**Quality report review of the hydrogeological and natural hazards ESIA studies for Nenskra
HPP, Georgia.**

Sylwester Kraśnicki, Ph. D.

Ludów Polski, May 2017

Fig. 3. Melting of Shdavleri Glacier compared to its previous extent in 1958.

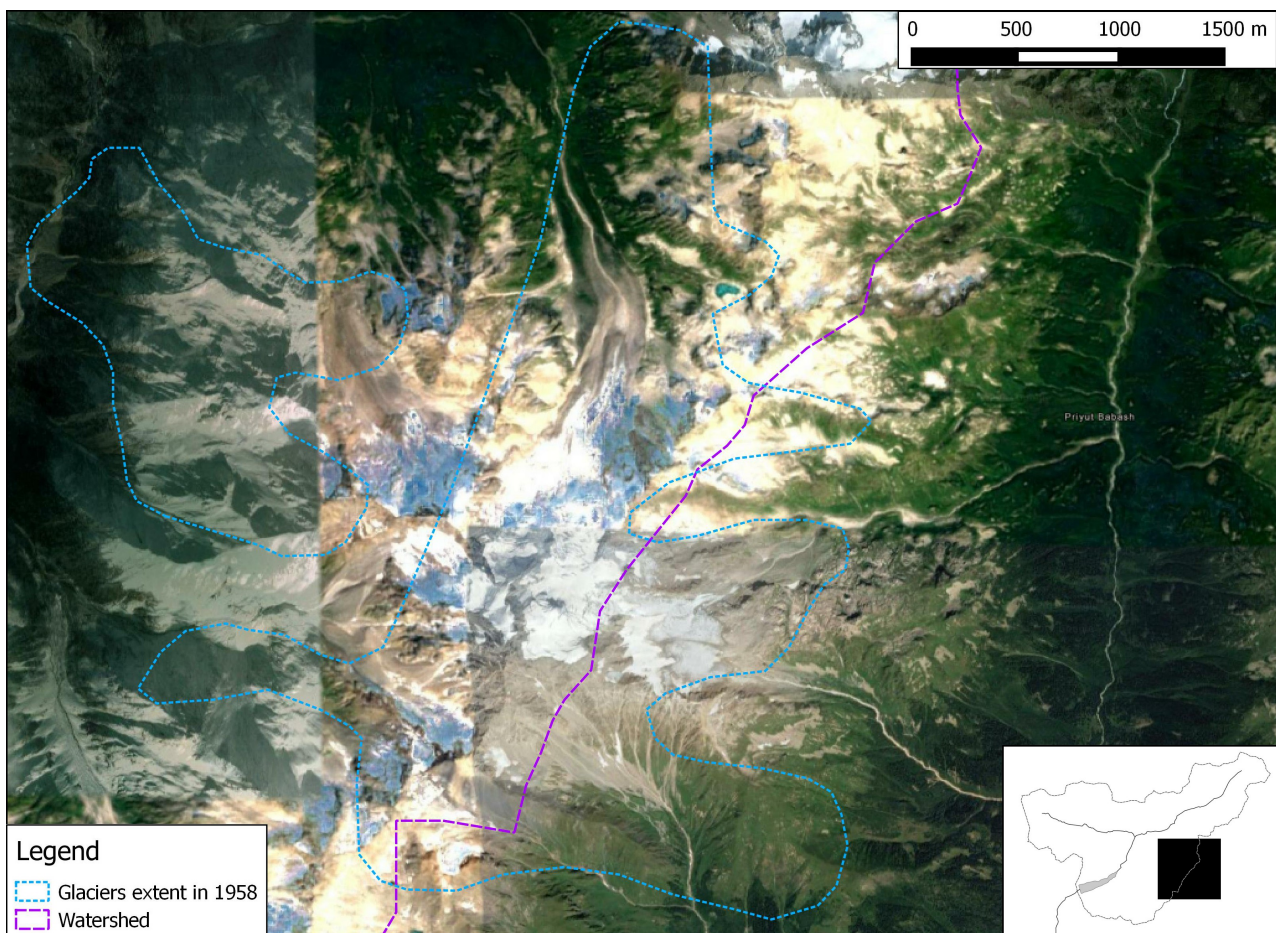
Melting glaciers impact. The area of interest is a catchment of Nenskra above the dam location. Besides geological and tectonic settings it is also needed to determine climate conditions and its predicted changes in the future. General information about mean annual air temperature ranges from +2°C to +4 °C in the valley but drops below zero on the Caucasus Ridge. Annual mean precipitation in Lakhmi is 1267 mm, but it rises along with altitude and reaches 3200 mm per year on the highest mountain ranges. Low air temperatures and high precipitation are the main cause of

glaciers presence in the highest parts of Nenskra catchment (Gvakharia 2015). In 2014 there were 67 glaciers in the Nenskra Basin and they covered 25,58 square kilometres. But in 1960 there were 75 glaciers and they covered 48,62 square kilometres (Tielidze et al. 2015). This means that climate change causes rapid melting of the glaciers. If the glaciers melting rate in the Nenskra Basin were constant, the last glacier in this area would disappear until 2075. Rapid melting of the glaciers results in water retention decrease and a general change of Nenskra flow regime, especially in the upper part of its basin. Flash floods may become more rapid and water stages during these phenomena may be higher. All the hydrological phenomena related to climate change should be modelled and their impact on the projected hydropower plant should be predicted, the especially influence of more rapid flash floods on the dam and water spill over the dam. Hydrologic consequences of climate change and glaciers melting were described in the ESIA, vol. 5, section 8. The climate change risks described in this paragraph can be rated as high.

Fig. 4. The corrected watershed of Nenskra in Dalari Glacier area.

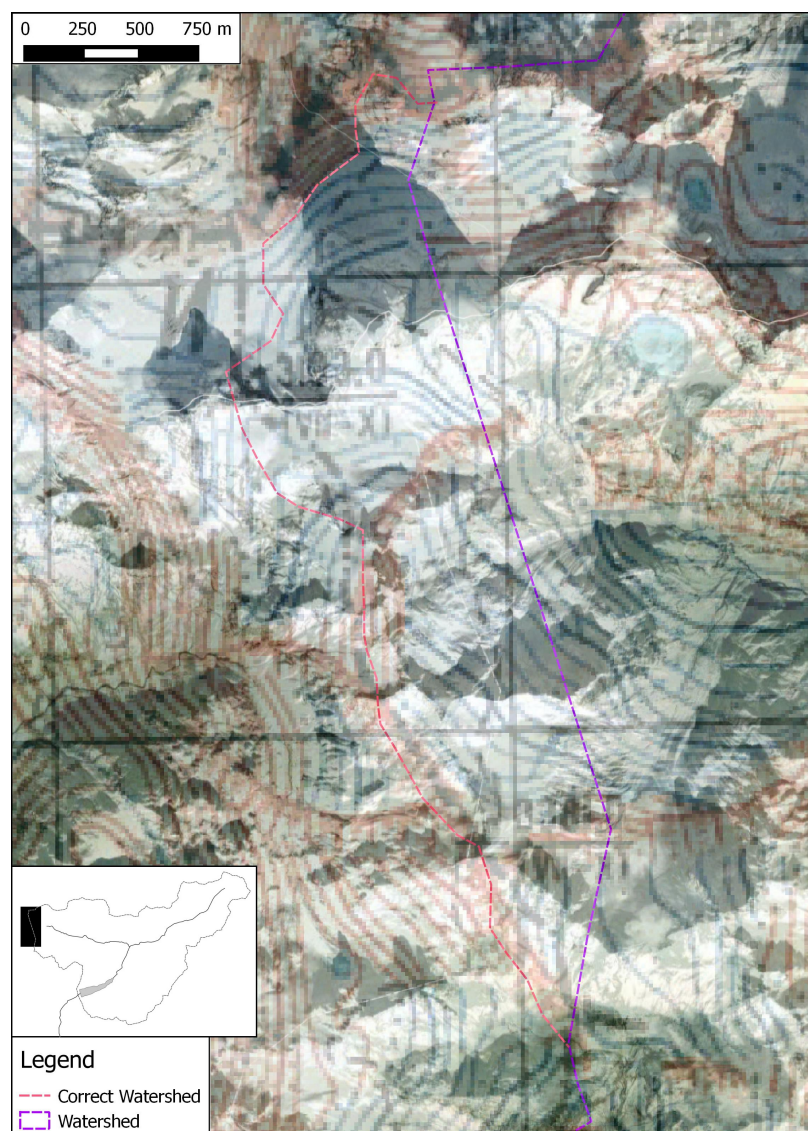
During analysis of Nenskra watershed in Dalari Glacier area, a controversy appeared. According to the authors of the ESIA (Bukowski, Cazaillet 2017), the watershed runs partially across the Dalari Glacier Valley as a straight line with only two points where the watershed changes direction. In a terrain of such a complicated topography (mountain range), it is not sufficient. The watershed should be conducted more carefully because this area is mostly glaciated and relatively large area of Nenskra catchment may be excluded – up to 3 square kilometres which are 12% of all glaciated area (Fig. 4). The glaciated area difference of this magnitude can lead to wrong conclusions about Nenskra flow regime predictions during climate change described in the previous paragraph and may result in similar consequences. The risk can be rated as high.

6. Watershed in the Dalari Glacier area needs to be corrected and assessed more carefully in order to avoid wrong data of the water balance of the Nenskra River Basin.
